2019/0323/P – Flats 1, 2 & 3, 3 Akenside Road. London. NW3 5BS

vDelegated Report (Members Briefing)		Analysis sheet		Expiry Date:	14/03/2019
		N/A / attached		Consultation Expiry Date:	24/03/2019
Officer			Application Number(s)		
Charlotte Meynell			2019/0323/P		
Application Address			Drawing Numbers		
Flats 1, 2 & 3 3 Akenside Road London NW3 5BS			See draft decision notice		
PO 3/4	Area Team Signature	C&UD	Authorised Officer Signature		
Proposal(s)					
Conversion of 2 x 3-bed flats to form 1 x 4-bed maisonette at ground and first floor levels; erection of single storey rear extension with roof terrace enclosed by balustrades; installation of 2 x new side windows at ground and first floor levels and 1 x new side door to form separate access to Flat 3; erection of new front bin store.					
Recommendation(s):		Grant Conditional Planning Permission subject to a Section 106 Legal Agreement			
Application Type:		Full Planning Permission

Application Ref: **2019/0323/P**

Photo 10: Existing first floor side stained glass window to be retained

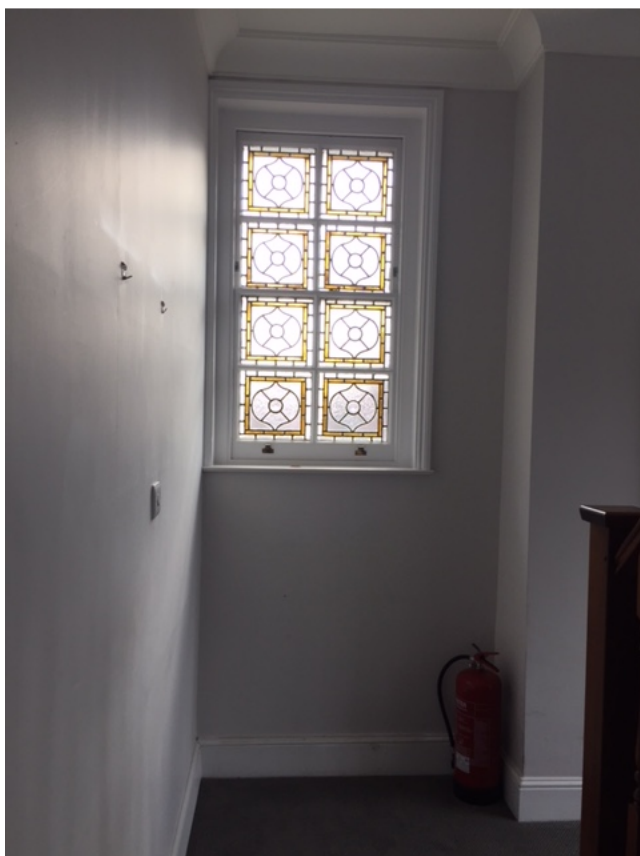
- 4.6 The proposal has also been revised to reduce the size of the proposed replacement first floor side window in order to retain the existing first floor side stained glass window, which is an important decorative feature of the building and the wider conservation area. The proposed first floor side window and enlargement of the existing ground floor side window to the rear extension would match the style of the existing windows, and are considered acceptable in design terms.
